PD Modification Application: MM 21-0556**Zoning Hearing Master Date:** September 13, 2021**BOCC Land Use Meeting Date:** November 9, 2021**Hillsborough
County Florida**

1.0 APPLICATION SUMMARY**Applicant:** Chestnut Hill Investments Five, LLC**FLU Category:** Suburban Mixed Use-6 (SMU-6)**Service Area:** Urban**Site Acreage:** 14.51 acres**Community
Plan Area:** Town N' Country**Overlay:** None**Introduction Summary:**

PD 18-1163 was approved in 2019 to allow for 72 single-family residential units. The applicant requests modifications to allow for a warehouse/distribution facility.

2.5 Proposed Site Plan (partial provided below for size and orientation purposes. See Section 8.2 for full site plan)

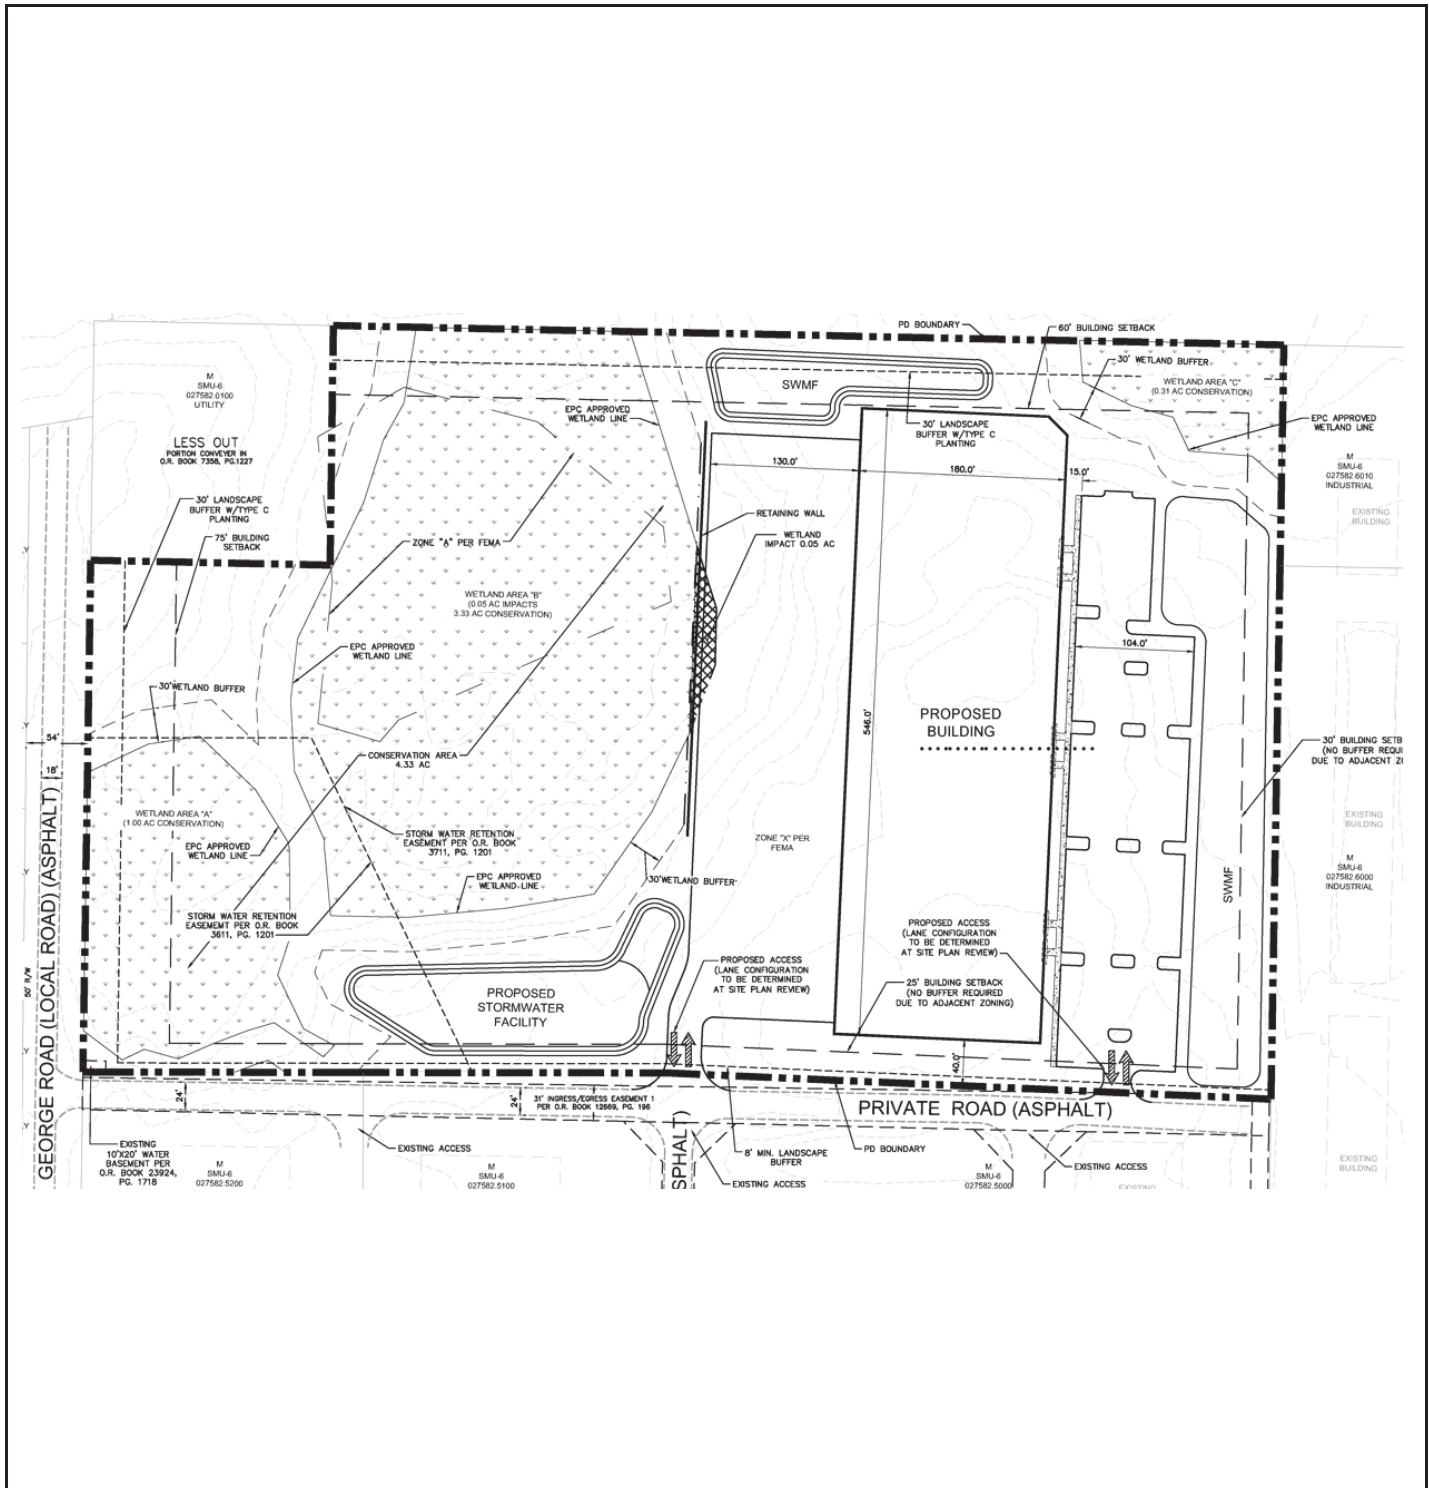
Prior to PD site plan certification, the applicant shall revise the PD site plan as follows:

Prior to PD Site Plan Certification, the applicant shall revise the PD site plan development summary proposed use to only include 100,800 sf warehouse building.

FIGURE 1
SIDEWALK IMPROVEMENTS

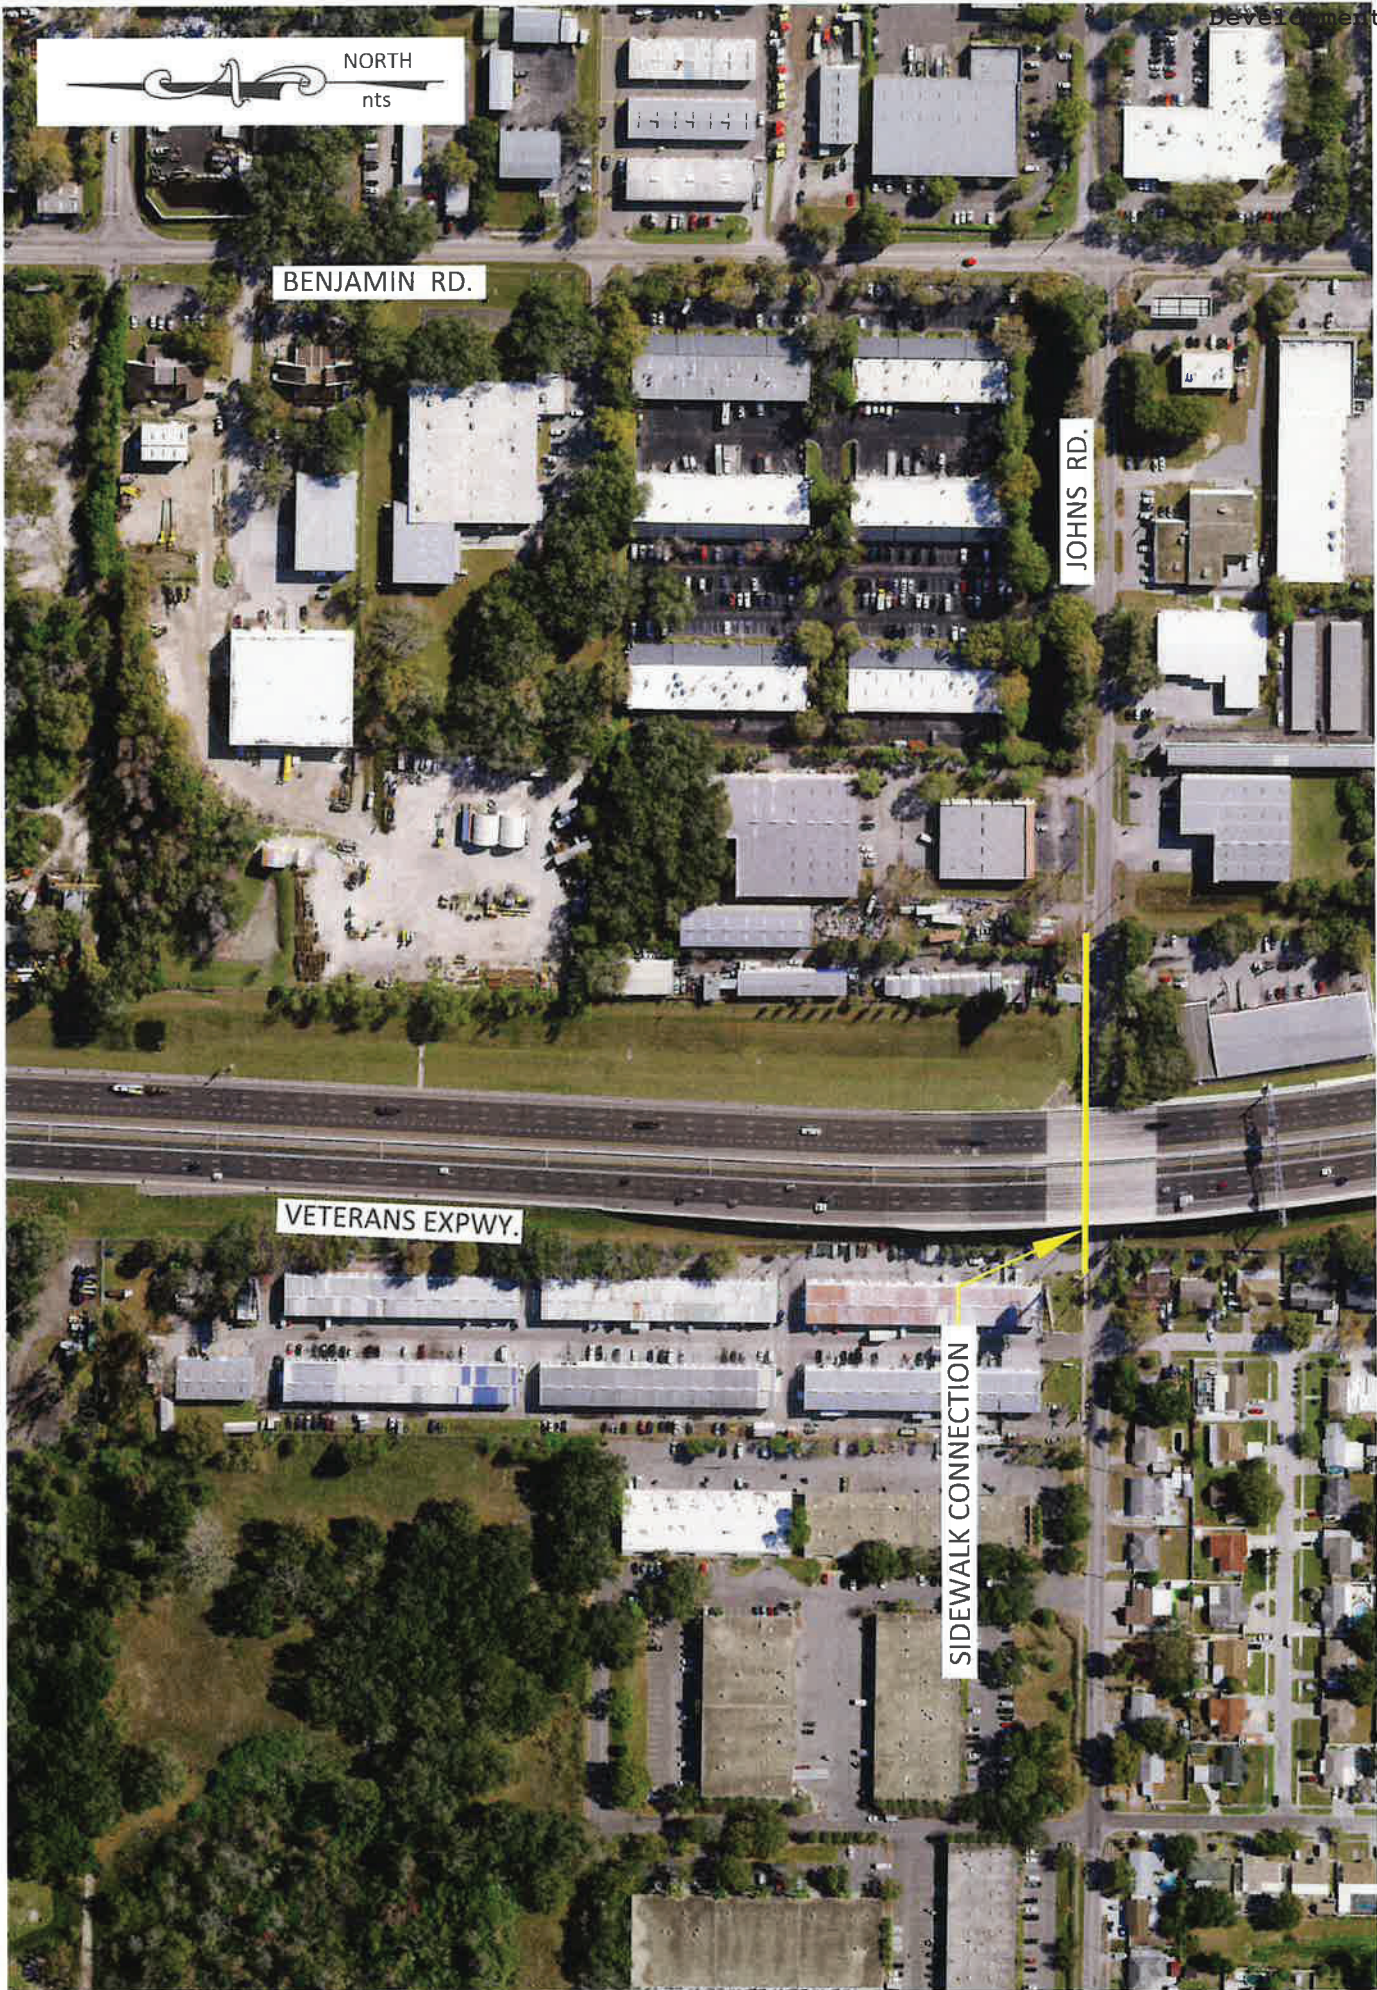
- 3) Sidewalk – TS-7 has 5 foot sidewalks on both sides of the roadway. The existing roadway has intermittent sidewalks along the subject section of Johns Road.

The developer proposes to construct the sidewalk gap as shown in Figure 1. This will provide continuous sidewalk on the northside of Johns Road from the project to Benjamin Road.

TS-7

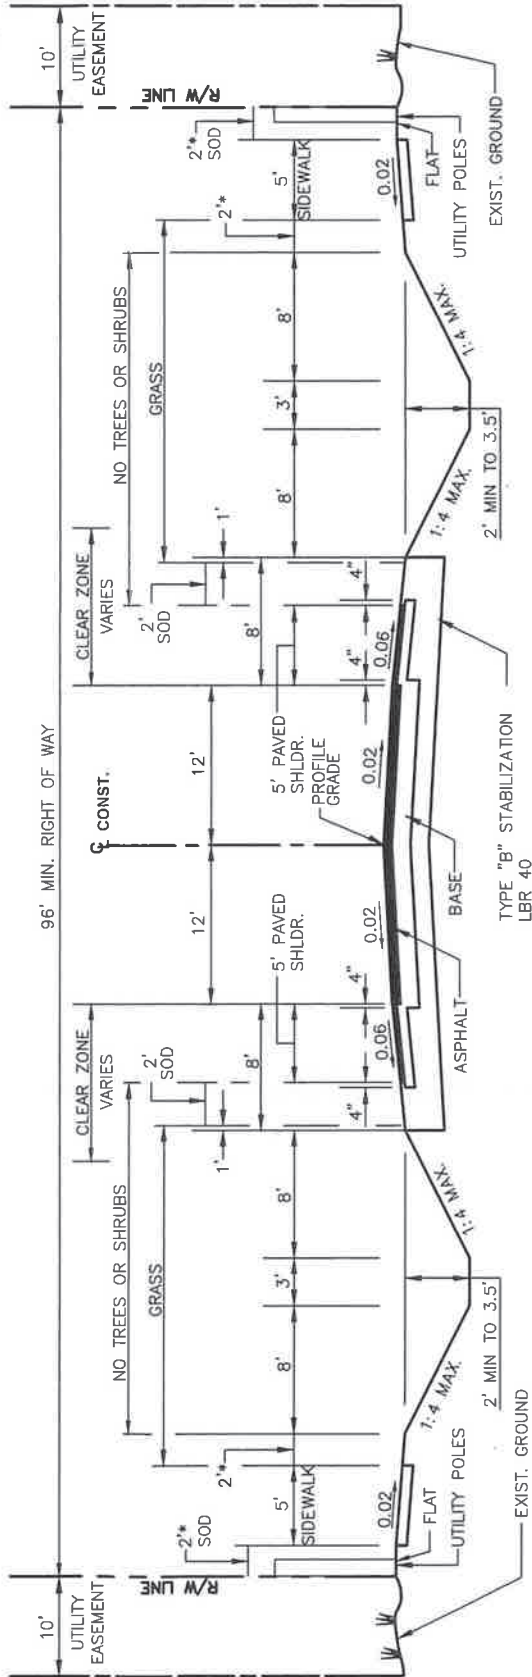
- 1) Lane Width – TS-7 has 12 foot lanes. According to the field measurements, the existing roadway has 11-foot lanes. The posted speed limit on the roadway is 25 MPH. According to Table 201.2.1 of the 2020 Florida Design Manual, 10-foot lanes are acceptable for Suburban (C3)/Urban General (C4) roadways with a design speed between 25 MPH and 35 MPH.
- 2) Shoulders – TS-7 has 8 foot shoulders with 5 foot paved. The existing roadway has intermittent unpaved shoulders and miami curb. There is not sufficient right of way to provide the paved shoulders.

FIGURE 1
SIDEWALK IMPROVEMENTS

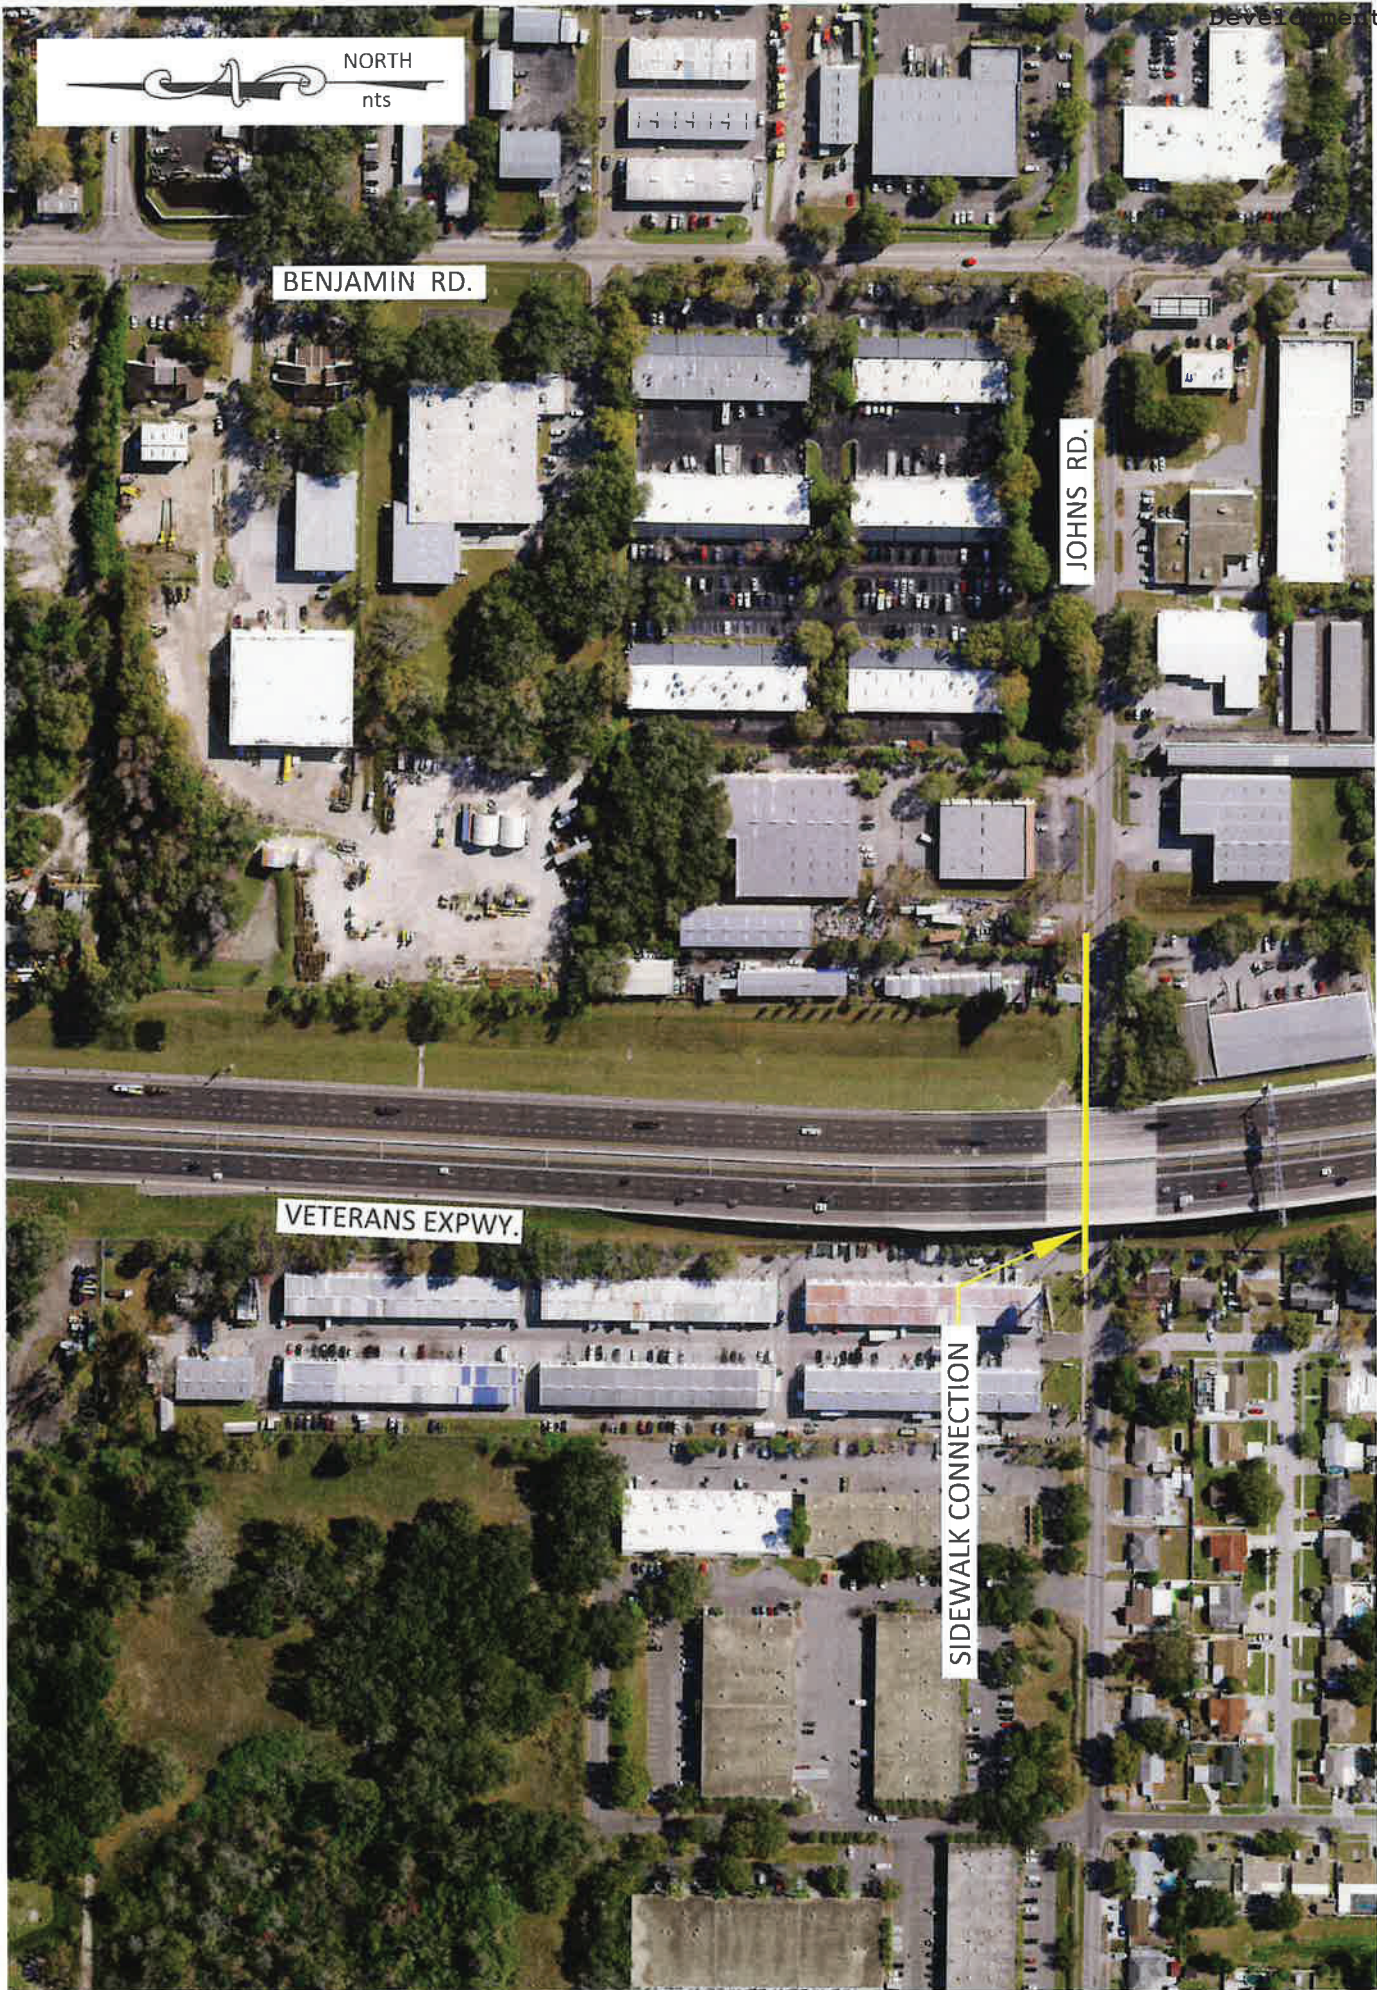
- 3) Sidewalk – TS-7 has 5 foot sidewalks on both sides of the roadway. The existing roadway has intermittent sidewalks along the subject section of Johns Road.

The developer proposes to construct the sidewalk gap as shown in Figure 1. This will provide continuous sidewalk on the northside of Johns Road from the project to Benjamin Road.
